APPLICATION NO.	FILING DATE	FIRST NAMED INVENTOR	ATTORNEY DOCKET NO.	CONFIRMATION NO.
10/788,788	02/26/2004	Michel Grandjean	040215-000000US	6142
20350	7590	11/14/2006	EXAMINER	
TOWNSEND AND TOWNSEND AND CREW, LLP TWO EMBARCADERO CENTER EIGHTH FLOOR SAN FRANCISCO, CA 94111-3834			COOLEY, CHARLES E	
			ART UNIT	PAPER NUMBER
			1723

Office Action Summary	Application No.	Applicant(s)
	10/788,788	GRANDJEAN, MICHEL
	Examiner	Art Unit
	Charles E. Cooley	1723

FINAL OFFICE ACTION

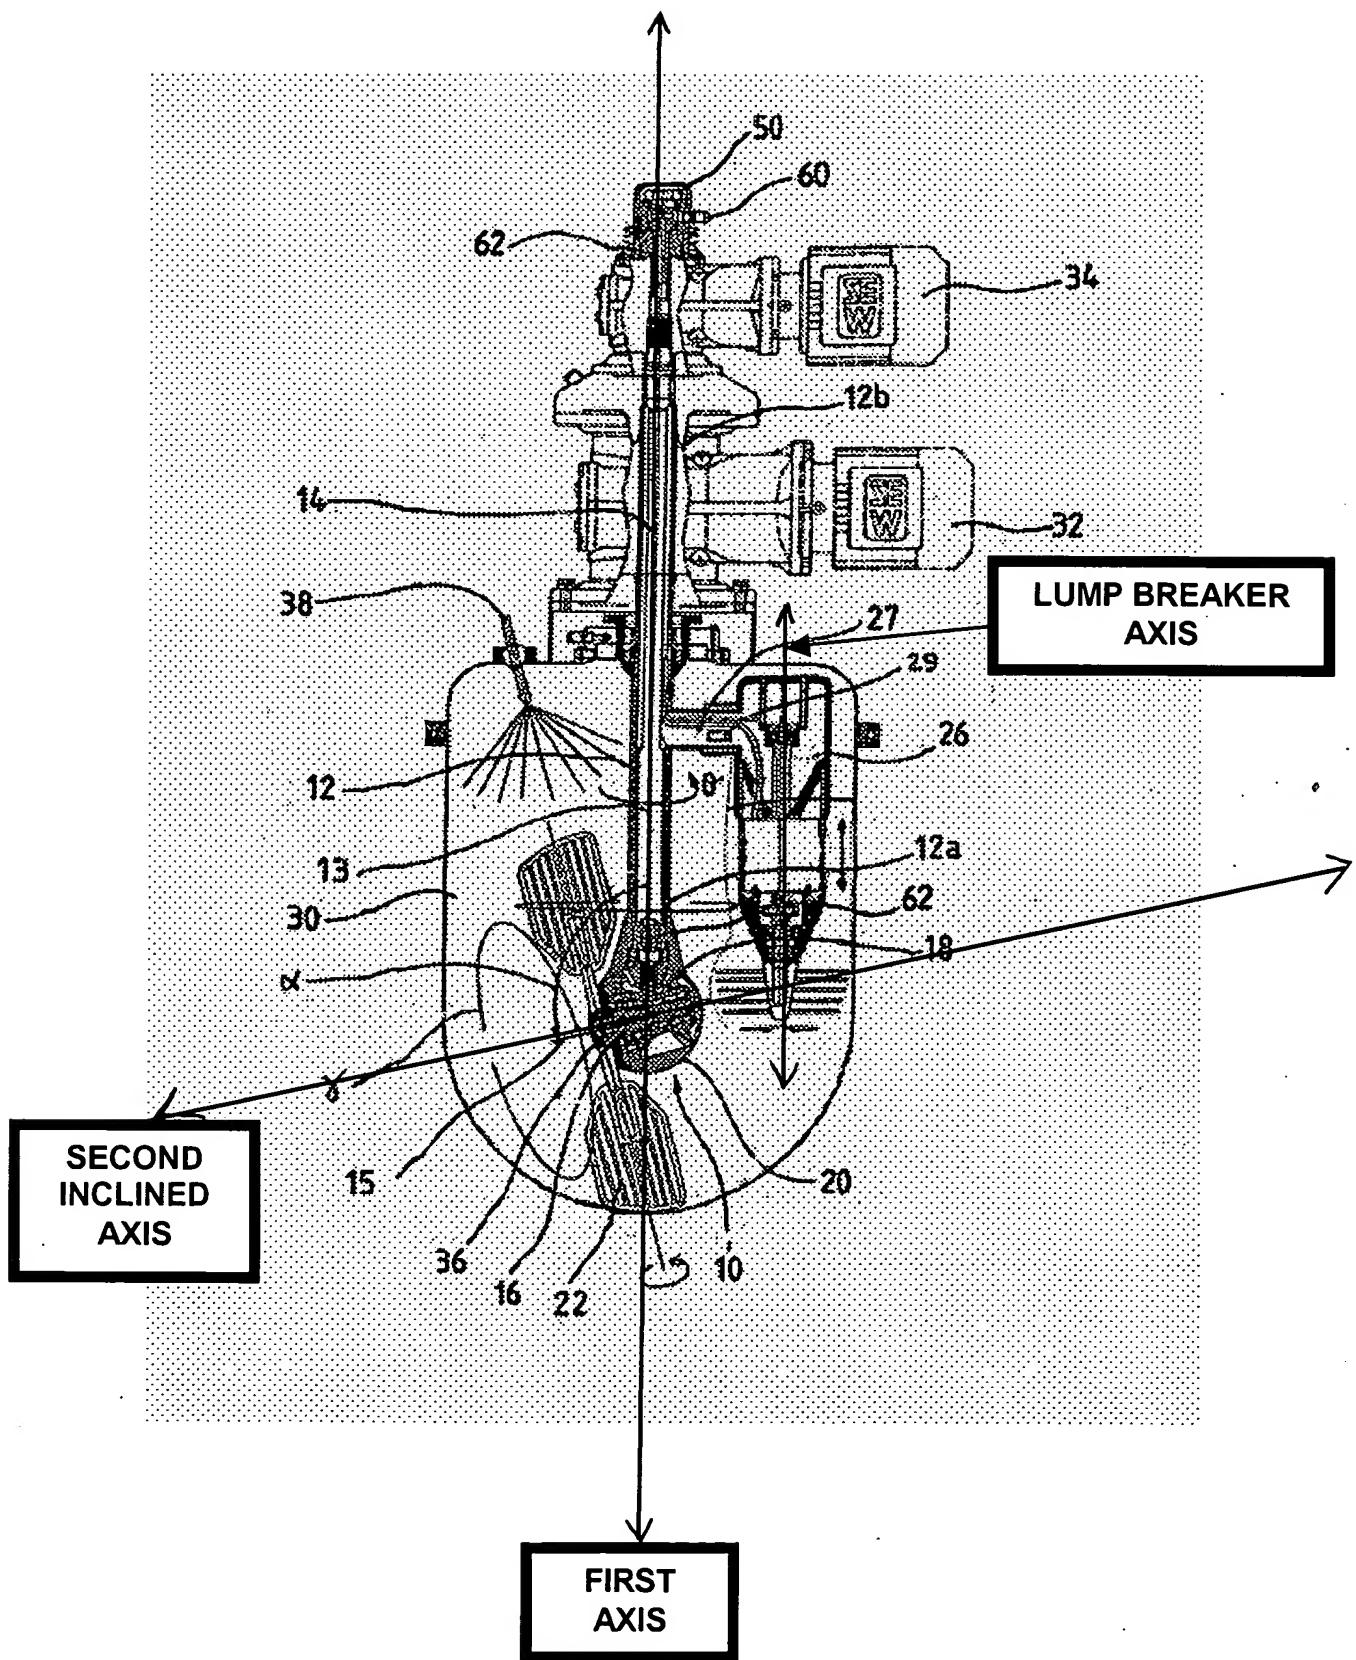
a. Contrary to Applicant's assertions, the subject matter of claim 15 remains not shown. In Figure 2 that Applicant refers to, the lump breaker 26 is shown along an axis oriented parallel to the first axis or an axis that intersects the second inclined axis (as defined by claim 1) but not along the inclined second axis. See the depiction below that reinforces this objection.

Claim 15 appears technically inaccurate. As noted and depicted above, the lump breaker 26 is shown along an axis oriented parallel to the first axis or an axis that intersects the second inclined axis (as defined by claim 1) but not along the inclined second axis. See the depiction below that reinforces this objection.
